RFTMA26-5334 - New School Construction Mayfield West No. 2 Public School

ADDENDUM NO. 3

July 21, 2026

SLIDING WHITEBOARD (SWB)
CLARIFICATION

43 SMT CLASSROOM 214 - D
A17 SCALE: 1 : 50

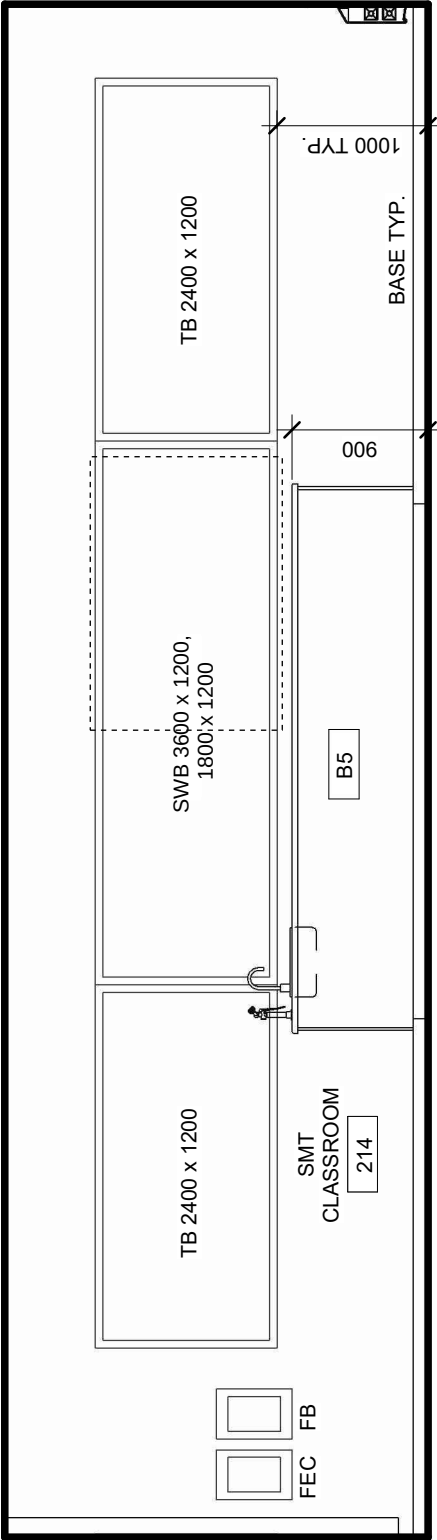
Item 10: 43/A17 SMT CLASSROOM 214 - D:

- .1 REPLACE interior elevation 43/A17 SMT CLASSROOM 214 – D with 43/A17 SMT CLASSROOM 214 – D per attached SKA A-100 Sliding Whiteboard (SWB) Clarification dated July 20, 2026.

2 STAC CLASSROOM 212 - B
A18 SCALE: 1 : 50

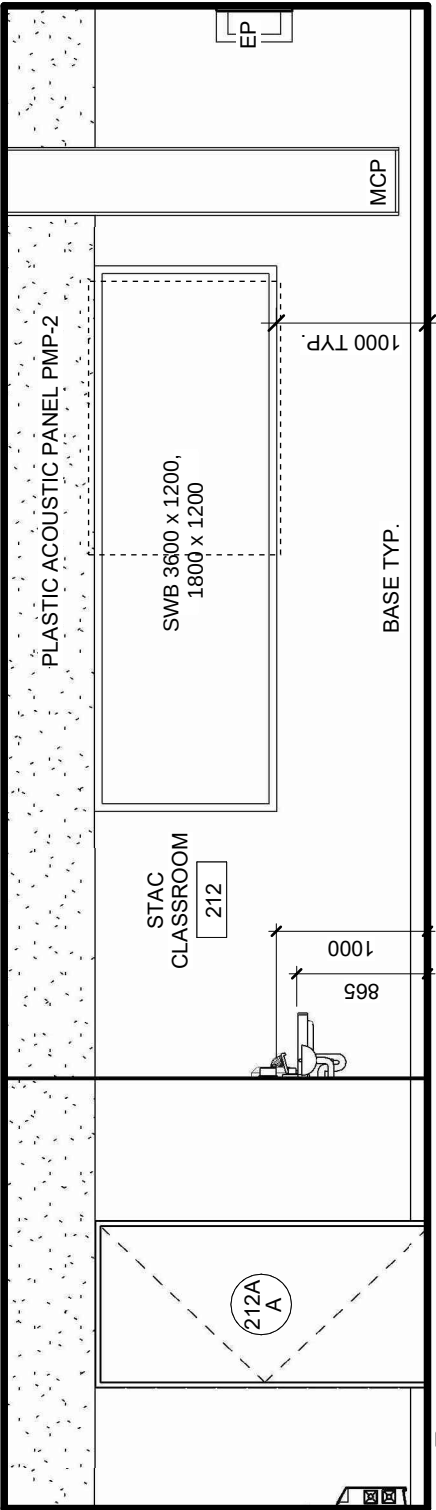
Item 11: 2/A18 STAC CLASSROOM 212 - B:

- .1 REPLACE interior elevation 2/A18 STAC CLASSROOM 212 – B with 2/A18 STAC CLASSROOM 212 – B per attached SKA A-100 Sliding Whiteboard (SWB) Clarification dated July 20, 2026.
